Rezoning Application: PD 21-0864
Zoning Hearing Master Date: January 18, 2022
BOCC Land Use Meeting Date: March 8, 2022

AGENCY REVIEW COMMENT SHEET

PETITION NO: RZ 21-0864

2.4 Proposed Site Plan (partial provided below for size and orientation purposes. See Section 8.0 for full site plan)

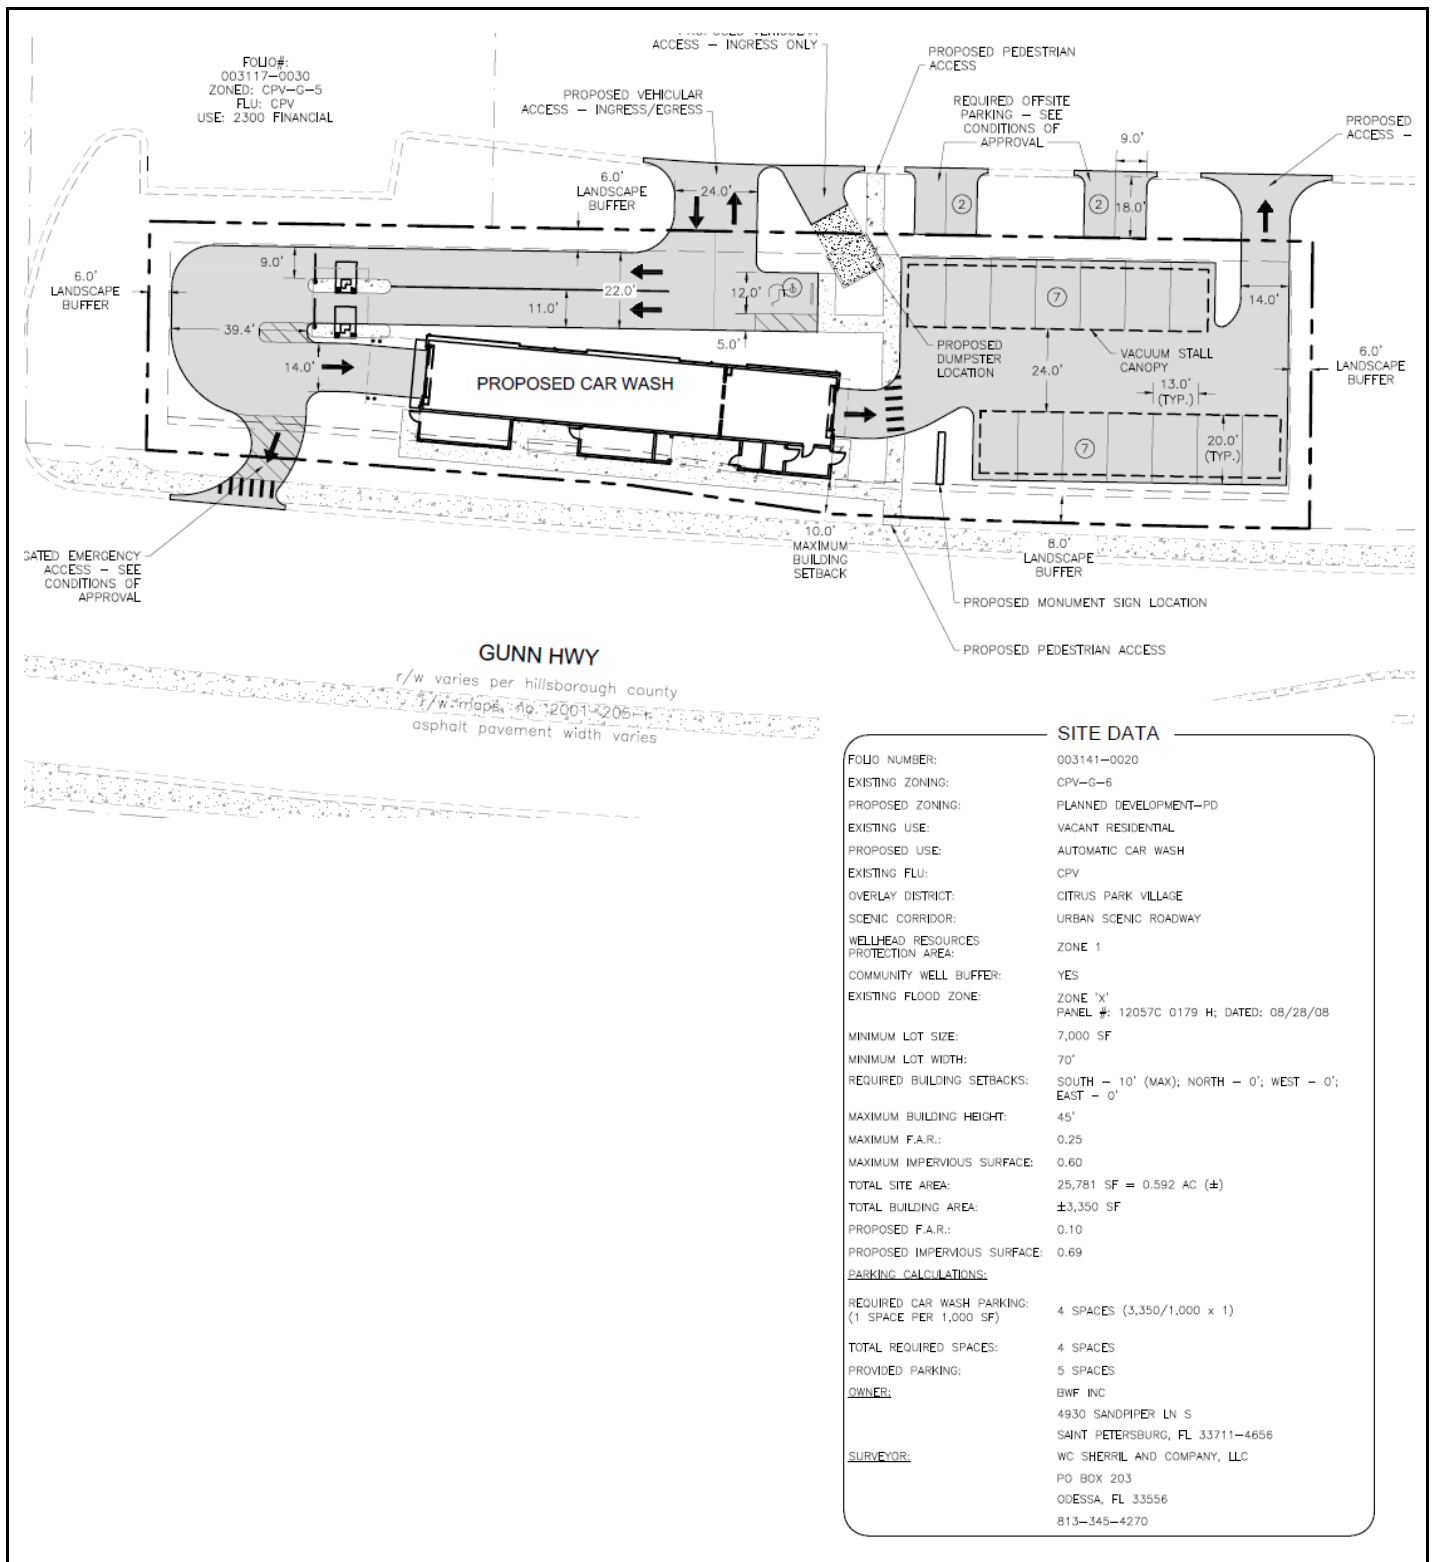
Staff has evaluated the explanations provided by the applicant. The site design, in relationship with the irregular shape of the lot in addition to the proposed building design, result in an overall project that conforms to the greatest degree practicable with the provisions of the CPV LDC regulations.

The majority of the front façade of the proposed building is being placed within the prescribed 10-foot maximum front setback from Gunn Hwy. The areas where the front façade is not meeting this requirement, a canopy, covering those areas, are placed at a similar distance from the front parcel line as the facades meeting the maximum setback requirement. The CPV regulation provides relief for projects required to be built to line or with maximum front setbacks. The proposed courtyards located

along the frontage will result with facades being further back no more than 20 feet from the front parcel line. Still, the building face meeting the maximum setback requirement will represent more than 67% of the entire front façade. The vacuum spaces placed to the side of the structure, function very similar to parking for the users of the car wash facility. The subdistrict G-6 allows for placement of parking areas to the side of the buildings in recognition of the restricted depth of the lot.

Prior to PD Site Plan Certification, the applicant shall revise the PD General Site Plan:

1. Amend the site plan to locate the dumpster enclosure at least 3 feet from the parcel line.
2. Add a note on the Site Plan identifying the location of the two courtyards along Gunn Hwy.
3. Update second sheet with the latest building elevations submitted on December 29, 2021

SITE ACCESS

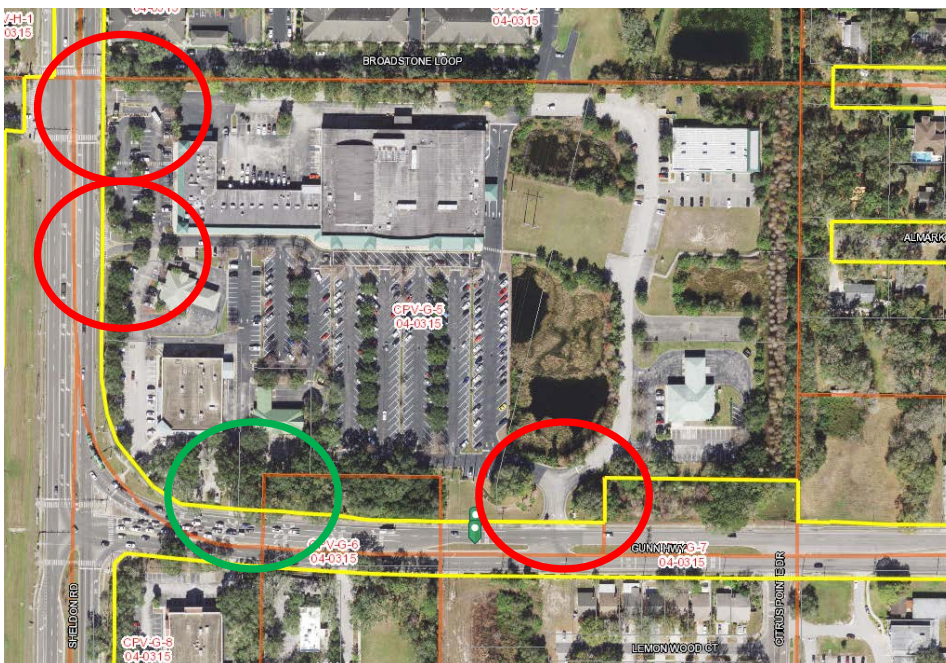
As required by the DRPM and staff, the applicant studied the access points that are anticipated to serve the project (even those access points aren't within the subject PD). The access connections anticipated to serve as primary access for the carwash are shown in red below (i.e. one access connection east of the site, and two connections northwest of the site). Other secondary access is shown as a green circle.

As described in the applicant's transportation analysis, there are existing left turn lanes into the northernmost and easternmost connections. While the applicant's Access Recommendations Table within the transportation analysis does not explicitly indicate the turn lanes are warranted, it does show right turn volumes at the southernmost connection (red circle) on the north-south of Gunn Hwy. and the easternmost connection on the east-west portion of Gunn Hwy. sufficient to trigger Section 6.04.04.D. auxiliary (turn) lane warrants whereby the Hillsborough County Land Development Code (LDC) requires construction of a turn lane. The applicant's analysis instead includes a footnote stating the turn lane is "Not recommend - See report". The report goes on to explain that the turn lanes are not recommended due to "right of way constrains and utility conflicts".

Turn lanes can only be waived via a Section 6.04.02.B. Administrative Variance (AV) from the Section 6.04.04.D. requirement to construct the turn lane. As a roadway safety related item, most Section 6.04 issues are under the sole authority of the County Engineer (including turn lane variances) and, consistent with current practice, most Design Exceptions and AVs must be processed concurrently with a PD zoning or zoning modification. Nevertheless, no requests for an AV or DE related to the turn lane was received. As such, staff has proposed a condition requiring the applicant to construct the required turn lanes.

3. The developer shall construct the following site access improvements prior to or concurrent with the initial increment of development:
 - a. A westbound to northbound right turn lane on Gunn Hwy. into the access serving folio 3147.0000; and,

- b. A northbound to eastbound right turn lane on Gunn Hwy. into the southernmost access serving folio 3117.0000.
4. Prior to or concurrent with the initial increment of development, the developer shall obtain an exclusive parking easement from the owners of 3117.0000 which permits the minimum required carwash parking to be located within the adjacent PD for as long as the carwash remains in operation, as well as permits construct of any other associated site improvements necessary within the adjacent folio. Written proof of the acceptability of such reciprocal easement to the County Attorney's office shall be filed by the applicant prior to or concurrent with site/construction plan review, and such easement shall be filed in the Official Records of Hillsborough County prior to issuance of Certificates of Occupancy (temporary or otherwise).
